**Urban Design Addendum – 2 Chifley
Square, Sydney**

The Draft Development Control Plan (DCP) for the planning proposal for 2 Chifley Square, Sydney proposes different tower massing to the proponent's lodged planning proposal and supporting studies. This addendum describes the differences, the reason for the change and briefly outlines where environmental impacts are different.

Axonometric view from the south-west

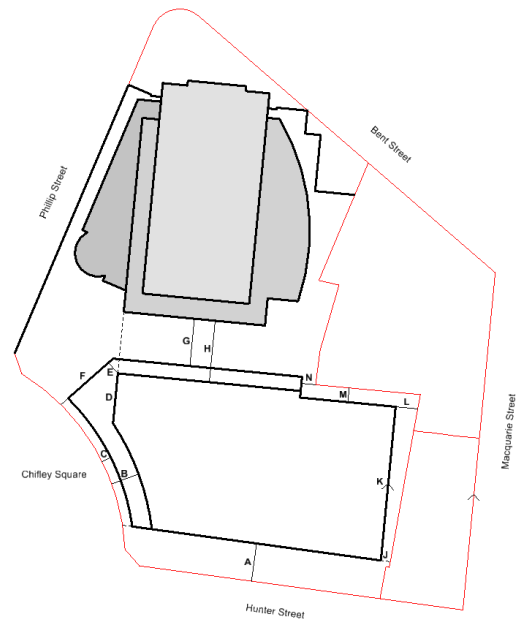
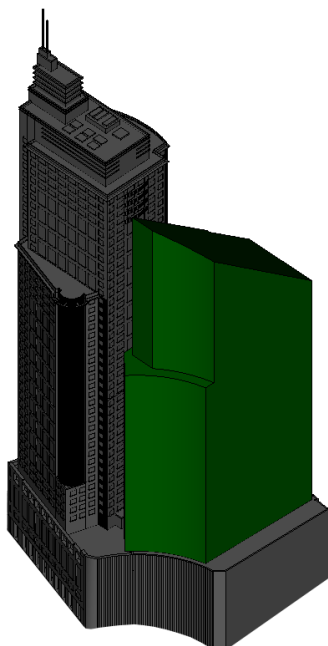
The differences are in the setbacks above the street wall.

The larger envelope extends up to 120m above ground level. Above this level the setback to Chifley Square and the separation from the existing building increase.

- has an increased setback to Hunter street from 4m to 8m
- is parallel to the curved geometry of the Chifley square with a smaller setback in the lower part of the control envelope and a wider presentation to the square and greater setback in the upper part
- includes a setback to the eastern side boundary
- has reduced separation to the existing tower and geometry that aligns with the boundaries and geometry of the existing tower.

These changes have been made in response to concerns raised by the City's Design Advisory Panel (DAP):

- In summary, given the close alignment between the lodged envelope and the lodged reference design, concern that the envelope needs to be expanded to allow greater flexibility for design innovation that provides an appropriate urban response.

- concern that the curved shapes of the envelopes may lead to a similar form as with the reference design, and are not necessarily contextual with the rest of Hunter Street and the existing Chifley tower.

- concern also that the curved alignment to south boundary of the envelope allows potential tower alignment too close to Deutsche Bank Place tower across Hunter St. Also and the view to sky and separation is critical here, and an alignment parallel to Hunter St is a better urban response.

- belief that more built form could move closer to the existing Chifley tower as that tower separation is less important than Hunter Street.
- the tower envelope should be set back a minimum of two metres and also be parallel to Macquarie Street.

- noting that the existing built tower modulates as it rises with stepped tower form (with three principal datums), the proposed envelope should facilitate similar stepping.

View 6 Botanic Gardens looking west p117

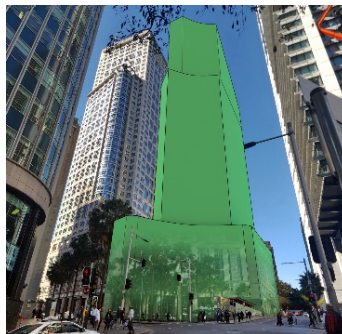
The changes do not create significantly different view effects.

The main change is that the proposed planning envelope will block more of the view of the existing Chifley Square tower viewed from the south along Phillip Street and Elizabeth Street where it rounds the corner into the square. This additional visibility of the proposed tower is acceptable.
